PRODUCT UPDATE

Cycle Gard® CI – CIN101

February 6, 2017

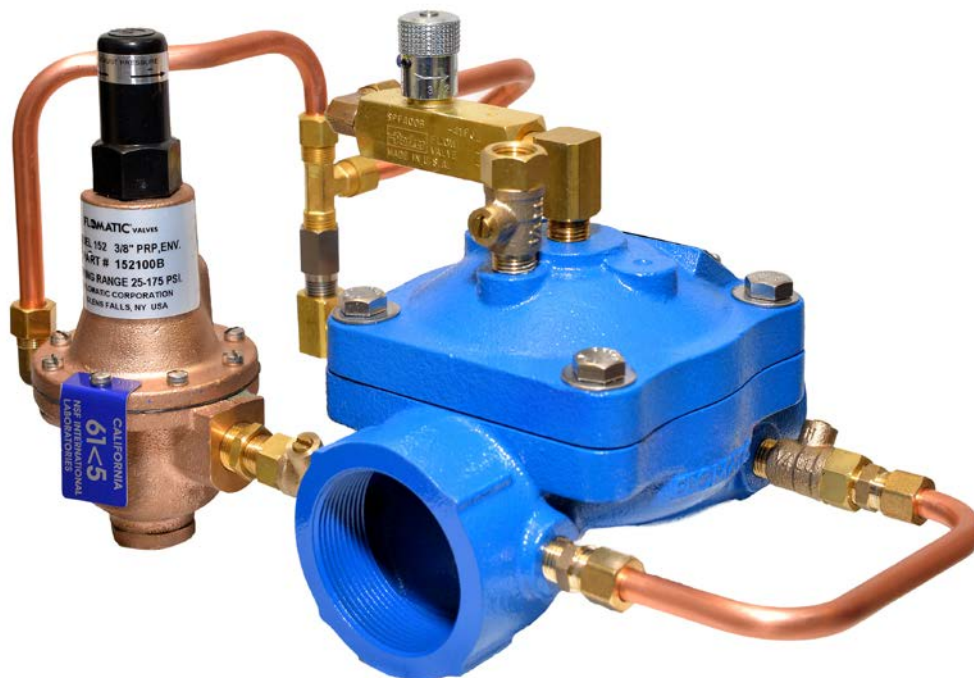
Effective immediately, all Flomatic **Cycle Gard® CI – CIN101** threaded models will be constructed with the new Cycle Gard® CI² main valve body. CI part numbers will remain the same. The original CI threaded body design along with the 3" and 4" flanged body styles have been discontinued and will no longer be available. For flanged models please see the **Cycle Gard® II** model.

The new CI² body design is more flow efficient and the flat diaphragm design allows for a longer more dependable service life.

Replacement diaphragms and springs will continue to be available for existing CI body styles already in service for serial #s 17036 and below.
